STAFF RECOMMENDATION

1703 Forrest Avenue

October 17, 2018

Application: New Construction—Addition (Revision to Previously Approved Plan)

Figure 1: 1703 Forrest Avenue

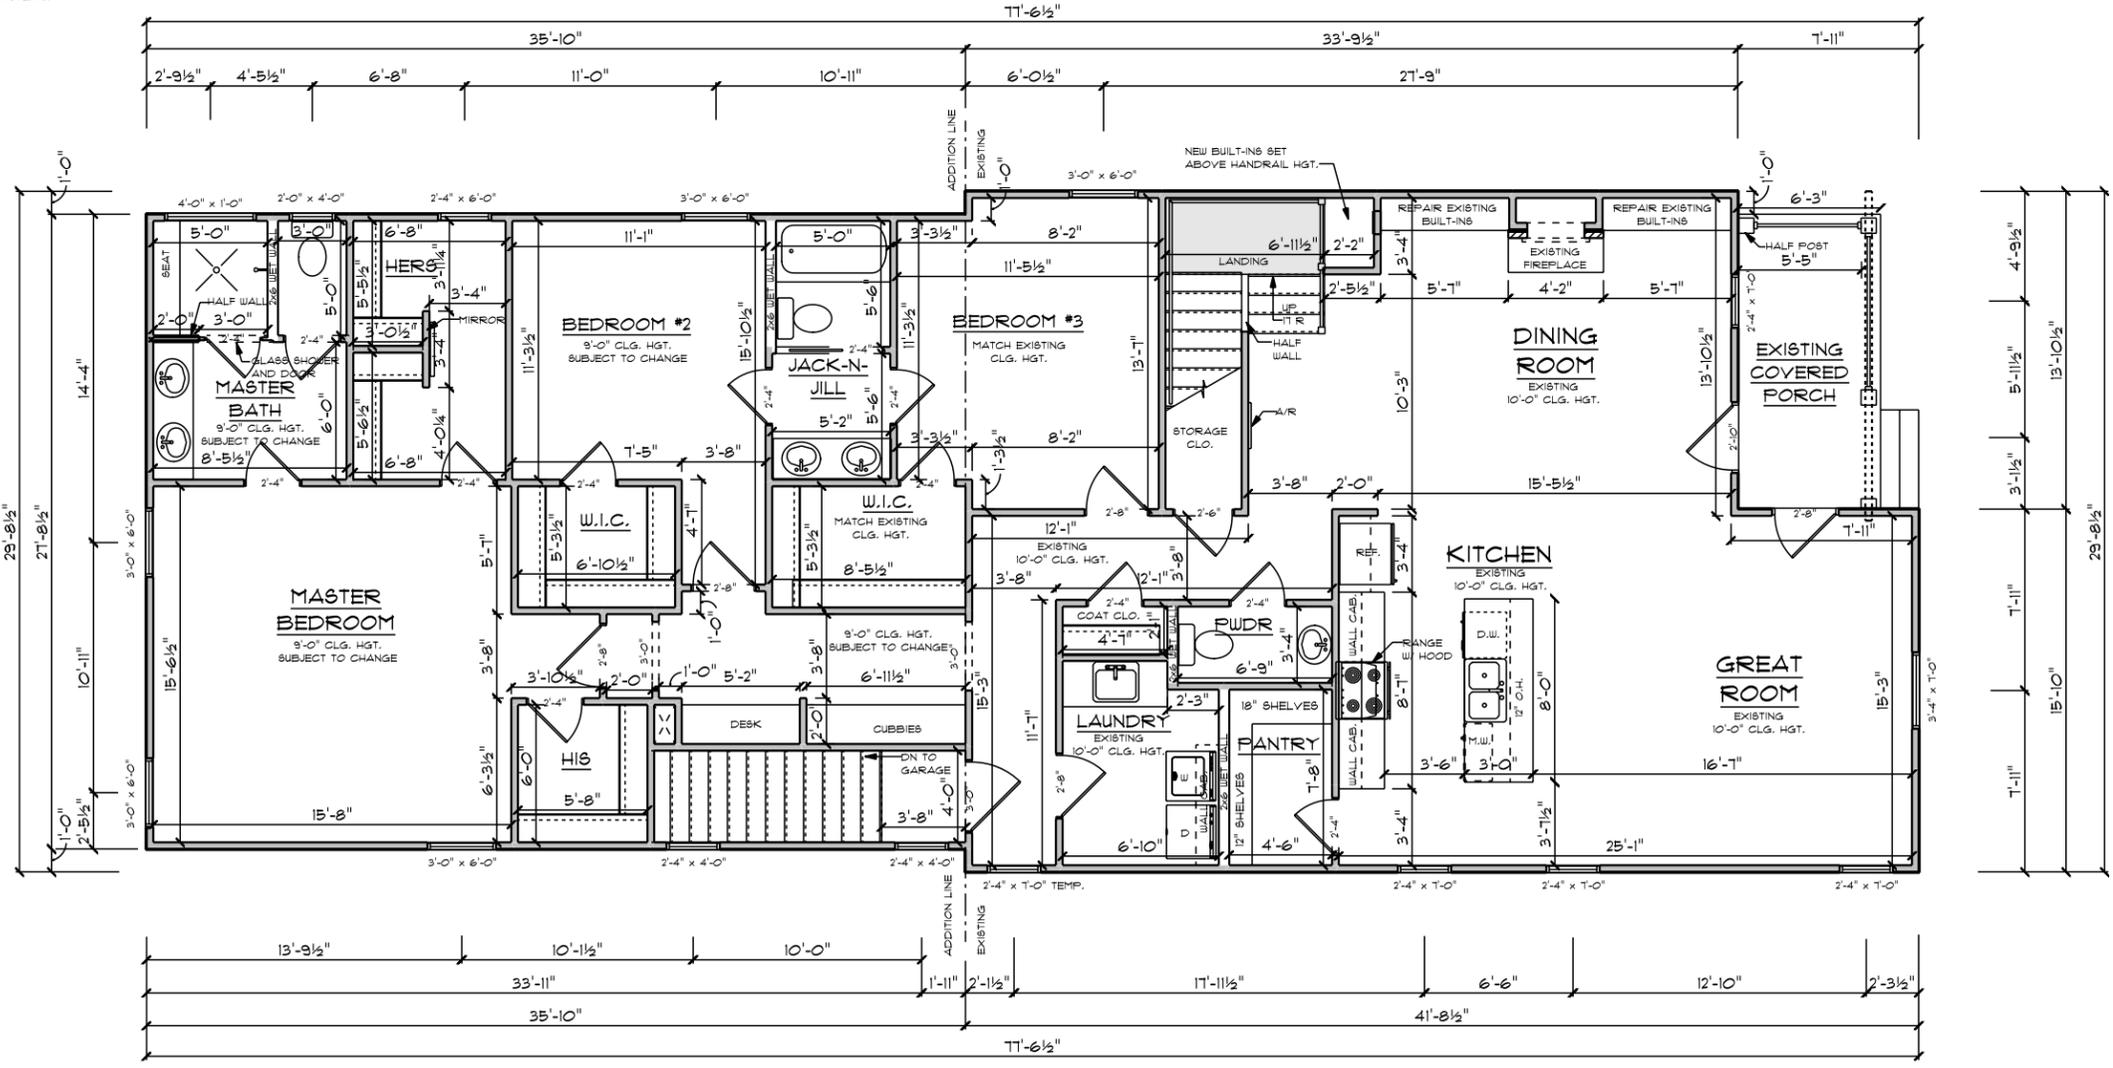
Analysis and Findings: The application is to revise a previously permitted rear addition. No changes are proposed to the footprint, materials, window or door openings, roof form, or setbacks. The only change is that the addition will extend two feet (2') taller than the historic house.

As originally approved the addition was no taller than the historic house, but the revised plan proposes that the addition extend up to two feet (2') taller at its tallest point. The design guidelines state that when an addition needs to be taller that the additional height should occur at least forty feet (40') from the front edge of the existing building. The proposed additional height begins forty-one feet (41') behind the front edge of the historic house. Staff finds that the additional height could be appropriate in this case since it is only two feet (2'), is located more than forty feet (40') from the front wall of the house, and most of the additional height that will be visible from the front is less than two feet (2') taller.

Since the rear addition is no wider than the existing house, does not more than double the existing footprint, the amount visible is only a portion of the addition, and the additional height can meet the design guidelines, staff finds that the rear addition is compatible in scale to the building and that the project can meet Section II.B.10.a of the design guidelines.

Recommendation: Staff recommends approval of the project with the following conditions:

1. Staff shall review and approve the materials for the siding, trim, roof color, windows, door, and garage door prior to purchase and installation;
2. Siding shall have a maximum reveal of five inches (5") and shall be smooth faced; and
3. The HVAC unit, if relocated, shall be at or behind the midpoint of the building.

FRONT ELEVATION

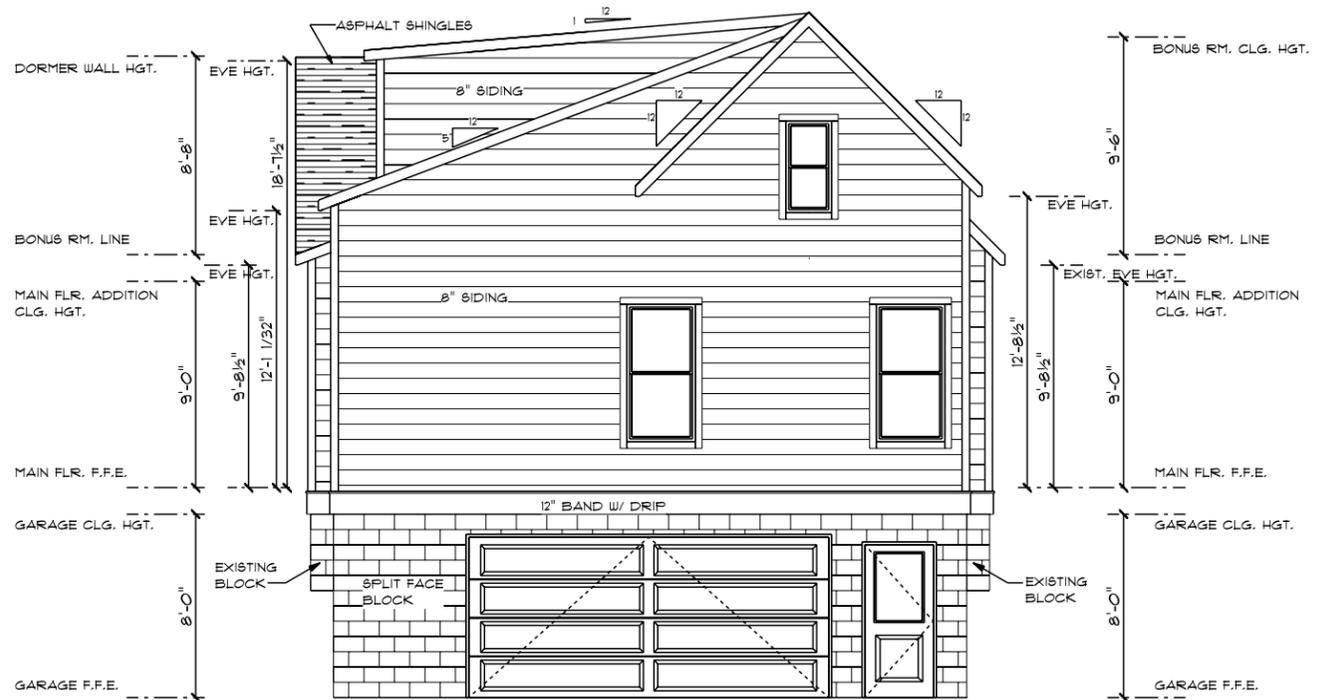
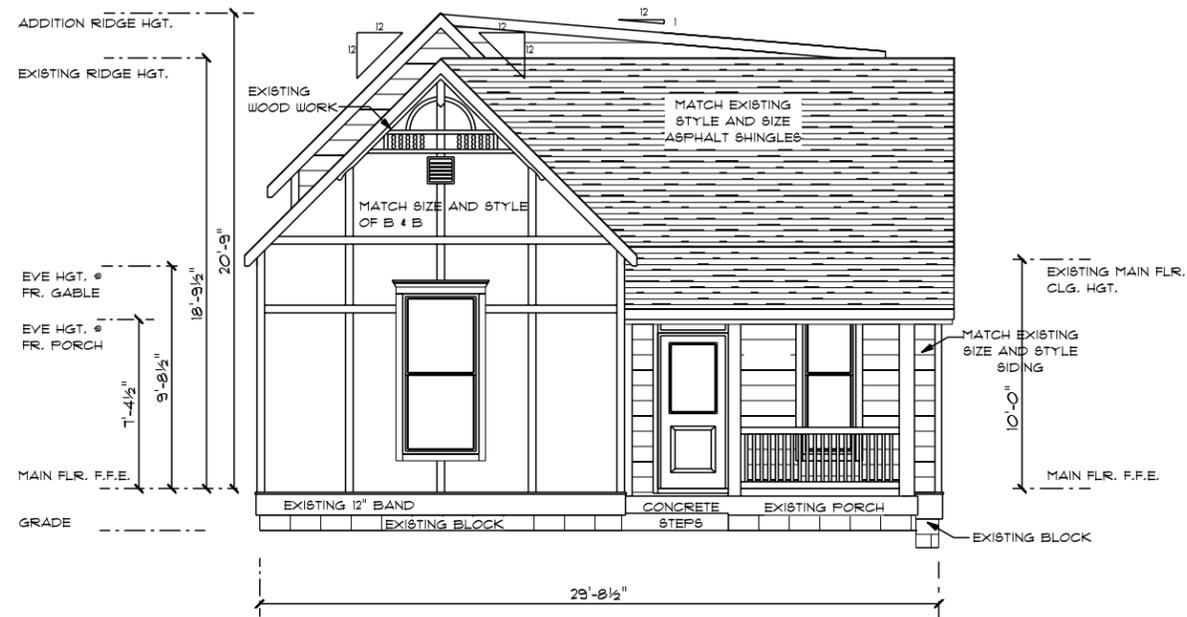
Roof form: The roof of the addition will be a rear facing gable, matching the form and pitch of the original roof. The request includes a lower sloped shed dormer on the right side façade. While the dormer is wide, it is located at the rear and will not only be set in two feet (2') from the wall below but also an additional foot (1') from the side wall of the existing house. So, in total, the new dormer will be set in three feet (3') from the existing side wall of the house. Staff finds the new roof forms are compatible with the roof of the existing house and that the project would meet section II.B.10.a of the design.

LEFT ELEVATION

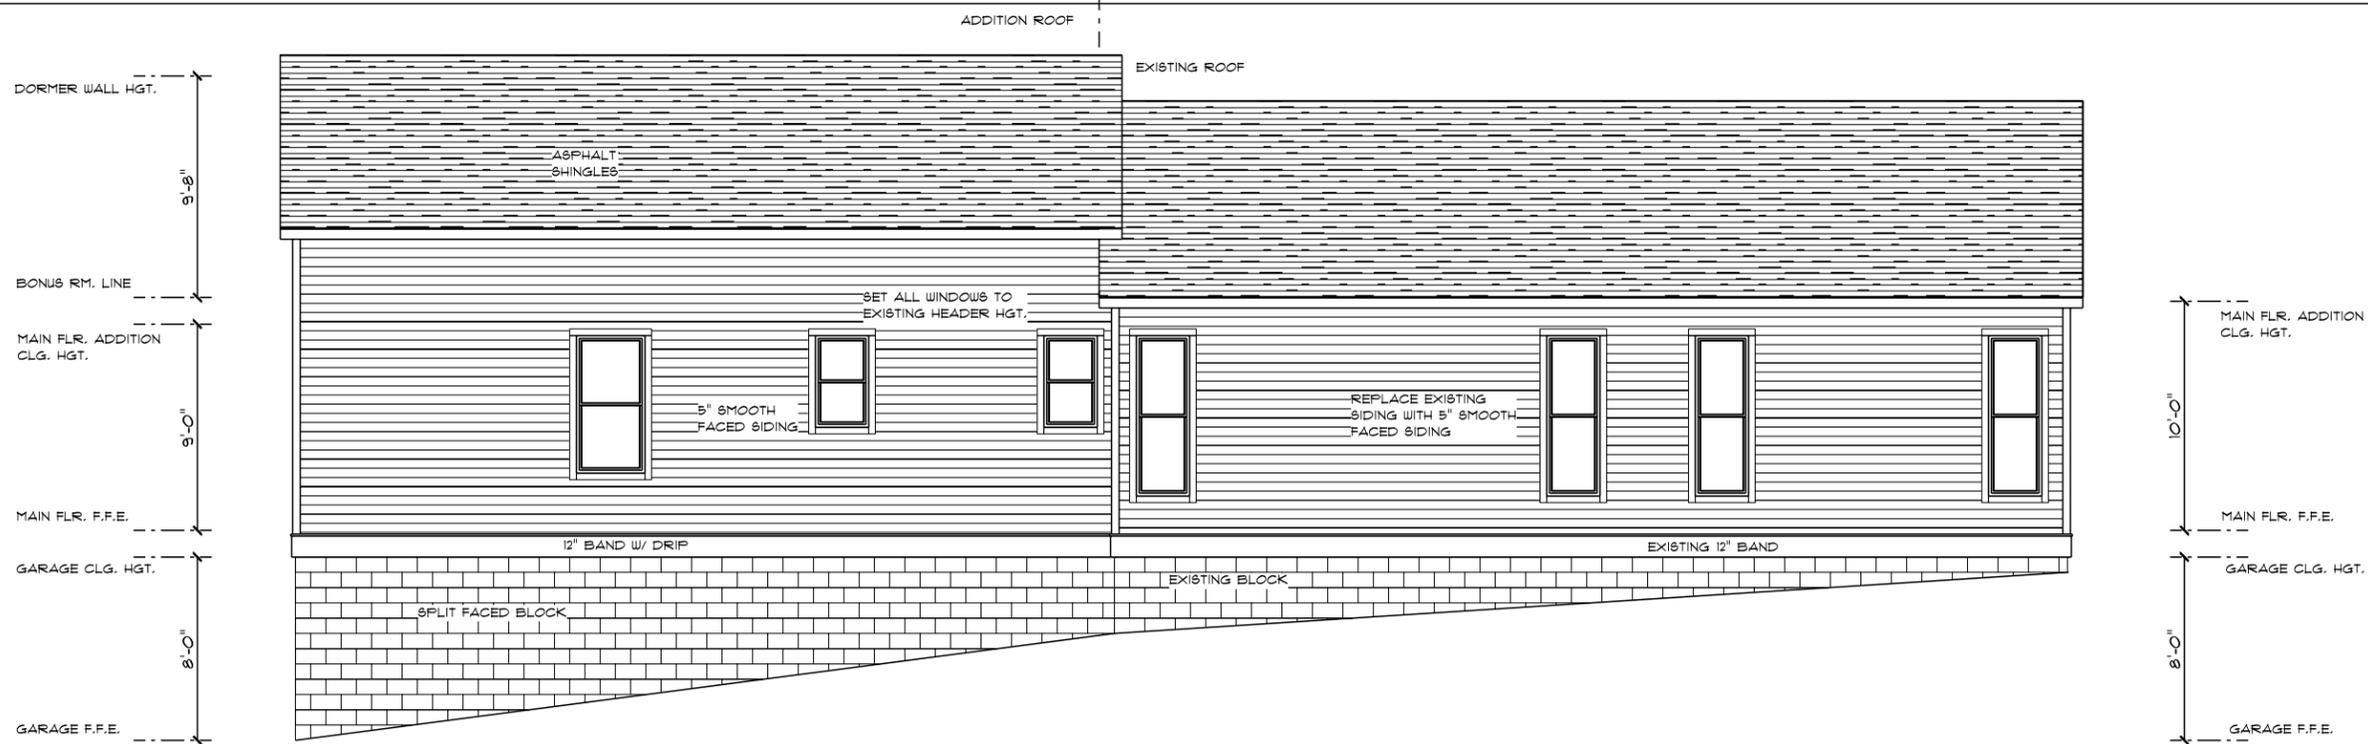
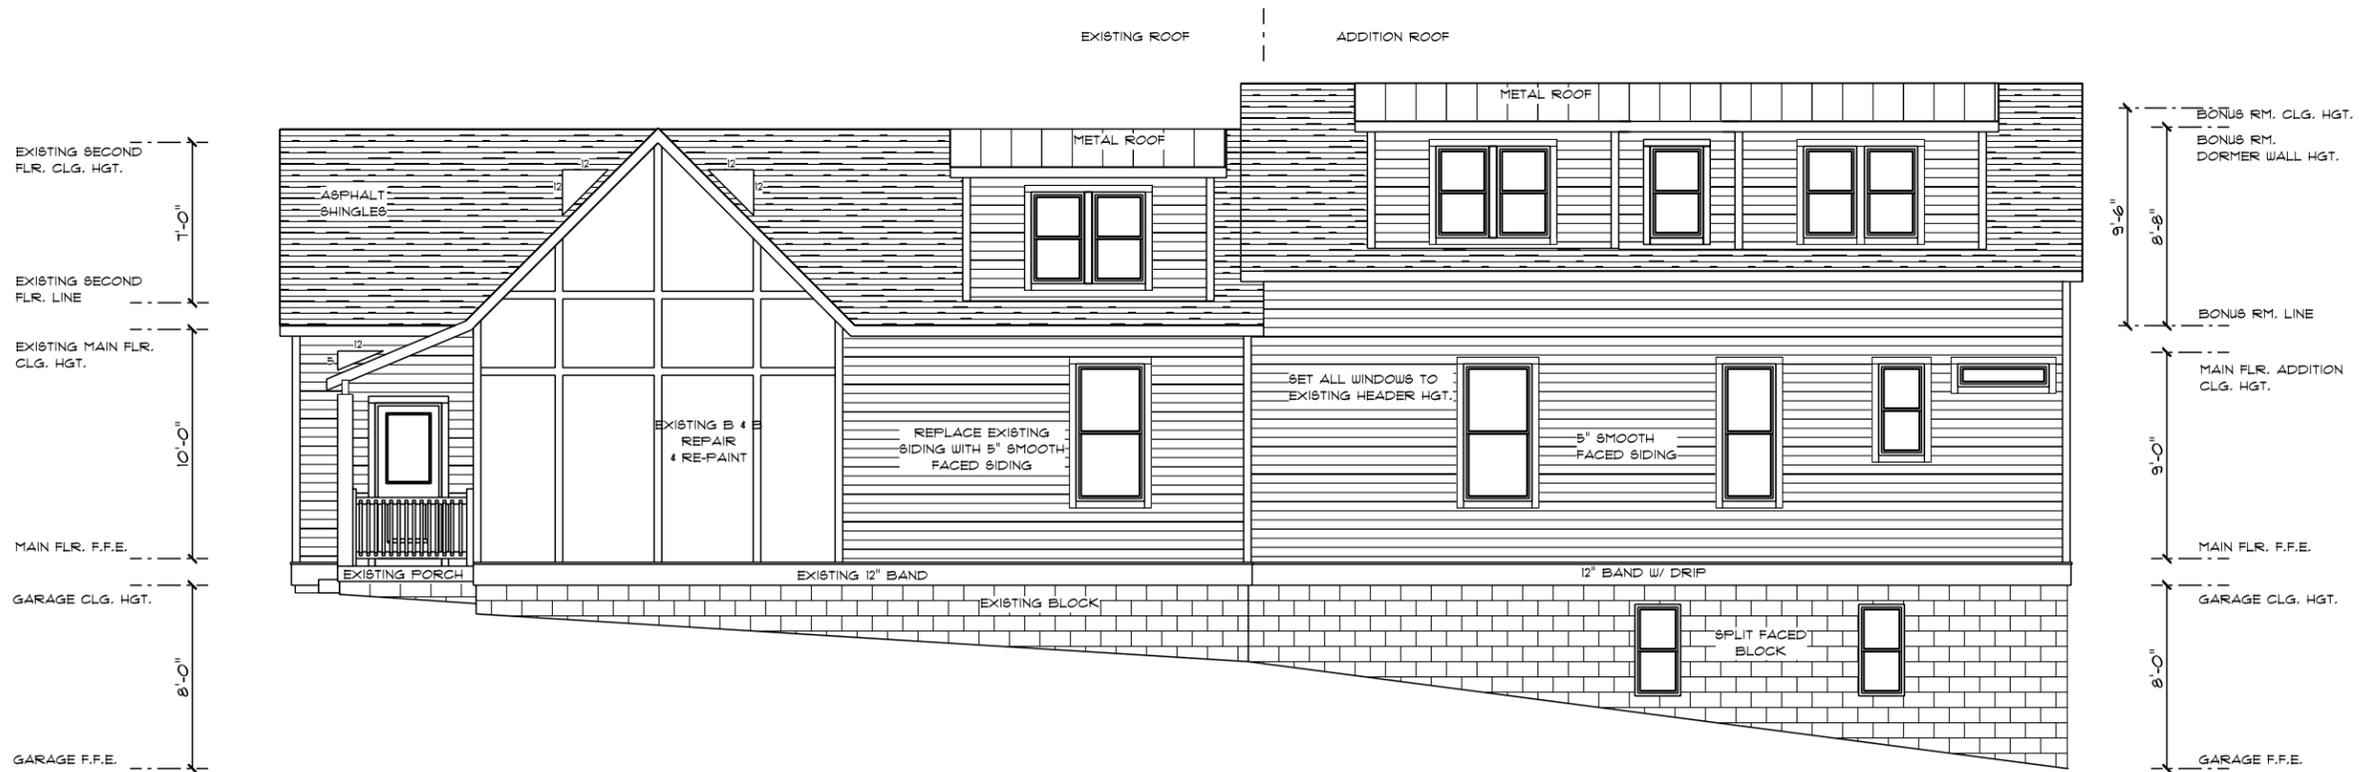
Proportion and Rhythm of Openings: The windows on the proposed addition are generally twice as tall as they are wide, thereby meeting the historic proportions of openings. The right side elevation of the addition includes a smaller horizontal window that could be appropriate as it is

located on the side façade near the rear of the house. Staff finds the proportions and rhythm of openings to be appropriate and to meet section II.B.10.a and II.B.10.b of the design guidelines.
